# UNITED STATES PATENT AND TRADEMARK OFFICE

APPLICATION NO.	FILING DATE	FIRST NAMED INVENTOR	ATTORNEY DOCKET NO.	CONFIRMATION NO.
10/509,135	09/27/2004	Donat Bosch	P/4637-3	1998
2352	7590	08/17/2006	EXAMINER	
OSTROLENK FABER GERB & SOFFEN 1180 AVENUE OF THE AMERICAS NEW YORK, NY 100368403			FRANCIS, FAYE	
			ART UNIT	PAPER NUMBER

**Office Action Summary**

**DETAILED ACTION**

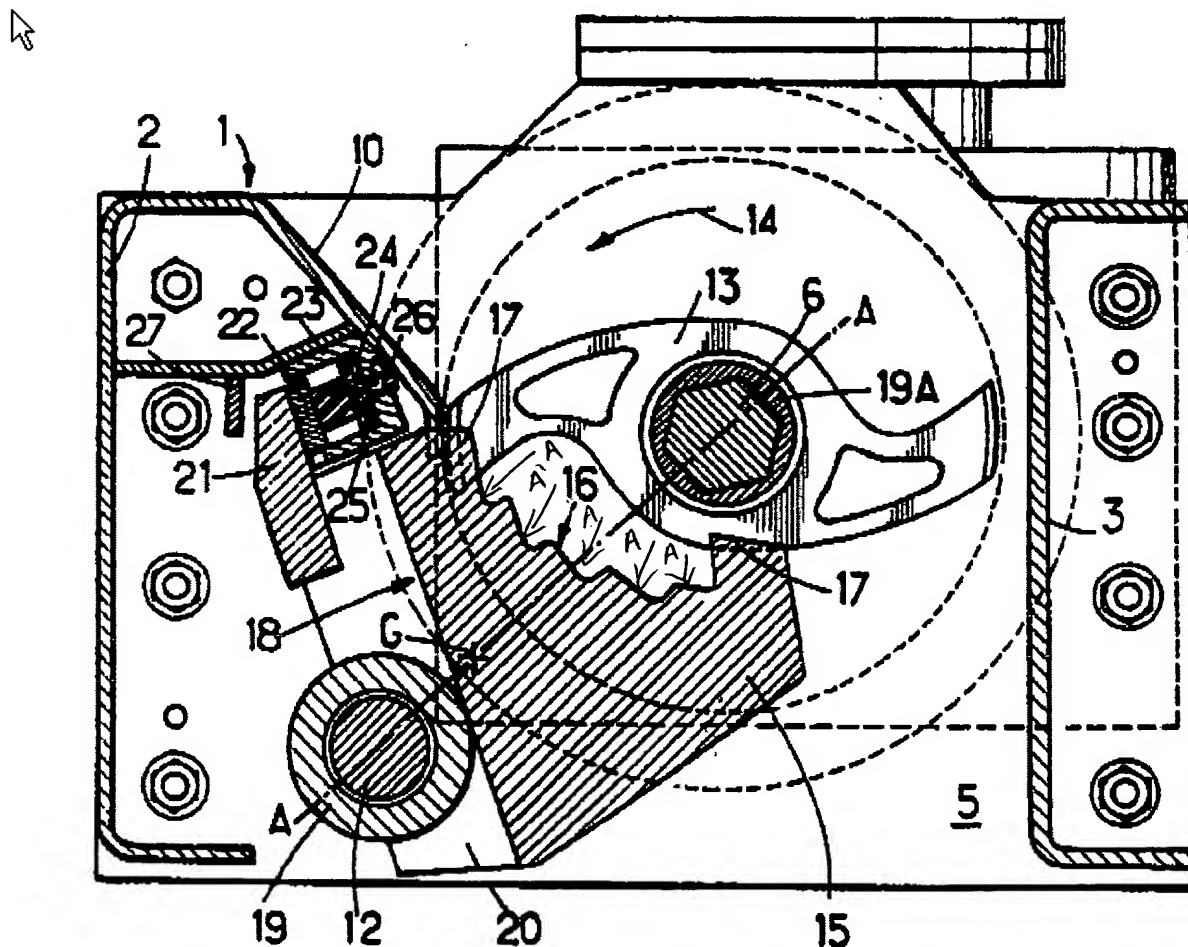
Ballu discloses in Figs 1-4 (also see Figure below wherein the letter A has been added by the examiner), a crushing device for crushing material, with at least one rotor 6 on the circumference of which a plurality of hooks [knives 13] are located, at least one stator [backing knives 15, sleeve 19 and plates 20] on which a plurality of crushing elements A located in a co-operating manner with the hooks are fastened, wherein the stator can be moved in the direction toward the rotor axis and twisted around a stator axis [col 4 line 46 to col 5 line 11] insofar as the applicant has claimed [as the stator is twisted it moves toward or away from the rotar]. Additionally, Ballu discloses that the stator is also movable either axially or transversally [col 3 lines 1-5], the crushing

elements are of a plate-like shape and have at least three lateral edges [Fig 2] and wherein depending on a selected twisting angle of the twistable stator one of the lateral edges [teeth 17] aligned transversally to the material flow direction is involved in the crushing and the twistable stators hydraulically lockable wherein the hydraulic locking of the stators de- activated on reaching a specified pressure load and blocked at a pressure load below the specified pressure load [col 5 line 30 to col 6 line 8].
